4 October 2016

ADDENDUM NO. 1

RE: City of Argonia, Kansas
Water System Improvements
KDHE Project No. 2702
WCI File: 09-200-513-00/05/8670/8600

DRAWING NO.: ARG-A160		OWNER: CITY OF ARGONIA, KS		INSTALLATION LOCATION: ARGONIA, KS	
D-SIZE SCALE: NTS		CUSTOMER: WILSON & COMPANY		MODEL NO.: PES54	
JOB NO.:		EQUIPMENT TYPE: PES SYSTEM		TITLE: EQUIPMENT ARRANGEMENT #GPM PES-54 SYSTEM

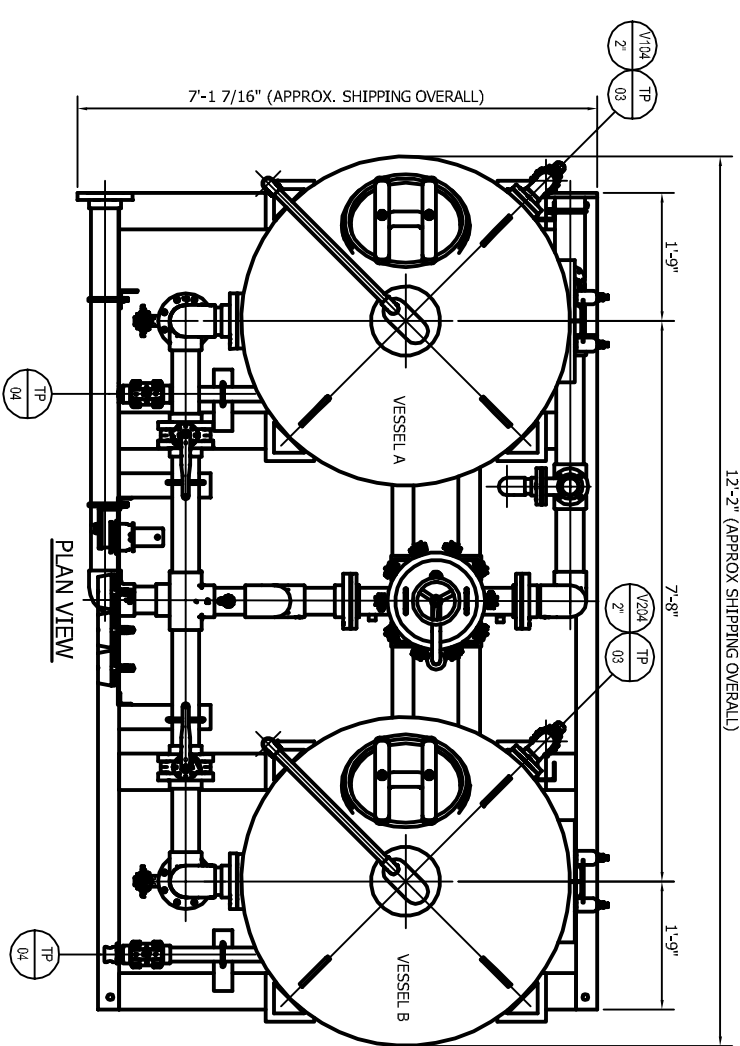
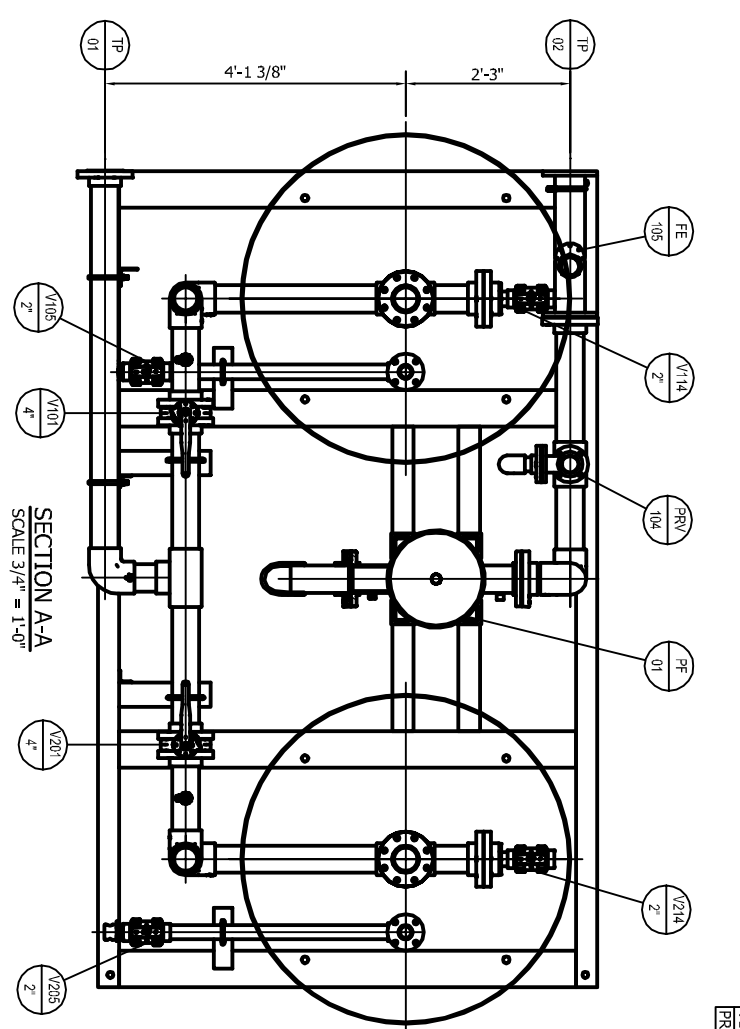
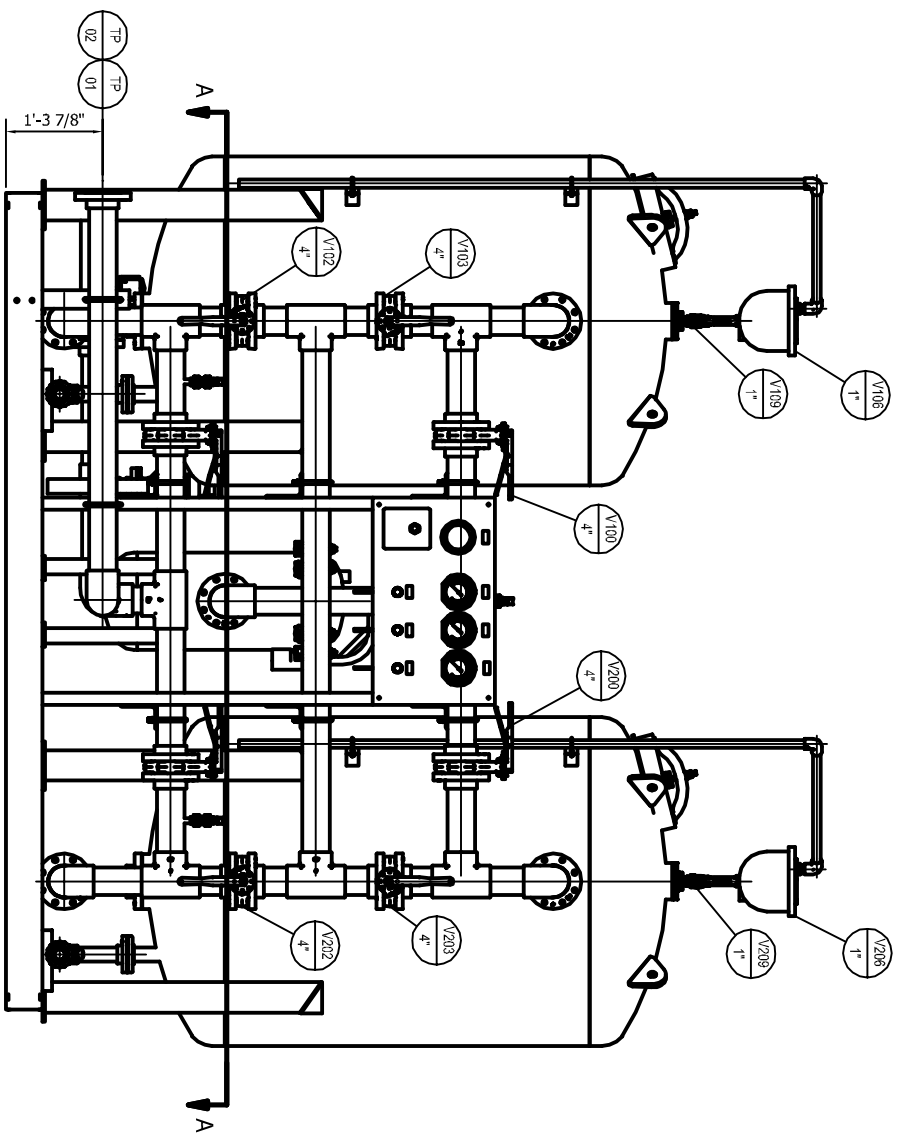
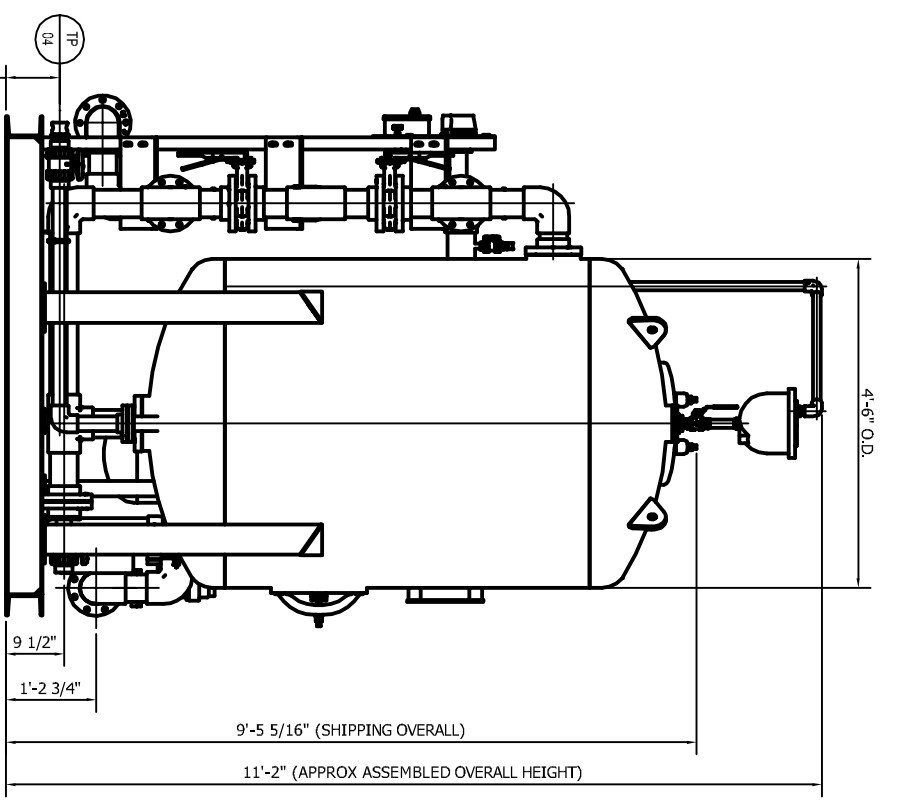
14. Section 11400A, Exhibit – Treatment Equipment, Page 11400A-1:
CLARIFICATION; actual Layne Christensen Bill of Materials (BOM) and Process and Instrumentation Diagram (P&ID) will be provided as part of shop drawing review after Purchase Order from Contractor. Provided BOM and P&ID for reference only.
ADD the attached drawings of the Layne Christensen equipment skids for reference only.
Actual treatment skid sizes will be provided by Layne during shop drawing review after Purchase Order from Contractor.

LAYNE CHRISTENSEN TO PROVIDE ACTUAL DESIGN AS PART OF SHOP DRAWING REVIEW AND SUBMITTAL.

A1 WATER TREATMENT PLANT - SOUTH ELEVATION

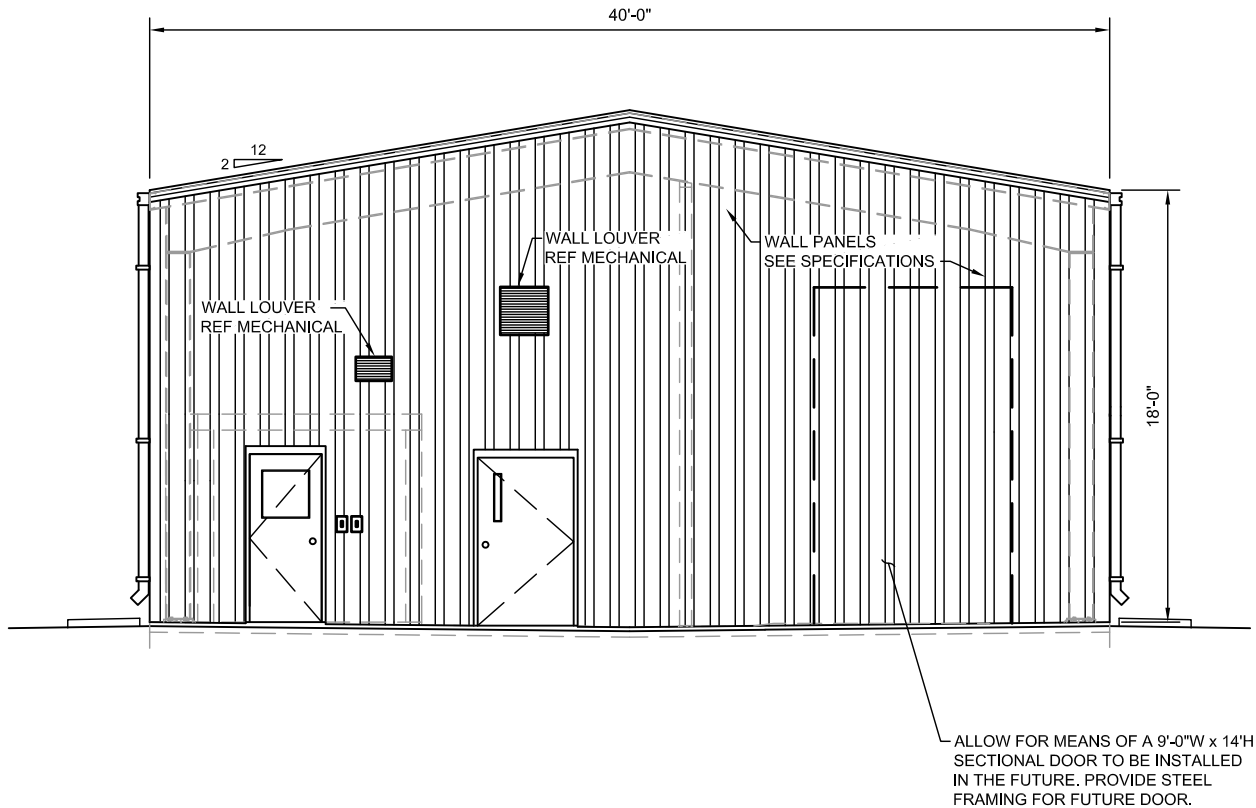
3. Sheet No. A-201, Water Treatment Plant Exterior Elevations

REPLACE detail A1 Water Treatment Plant – South Elevation with the attached detail A1 Water Treatment Plant – South Elevation on Sheet No. A-201A1.
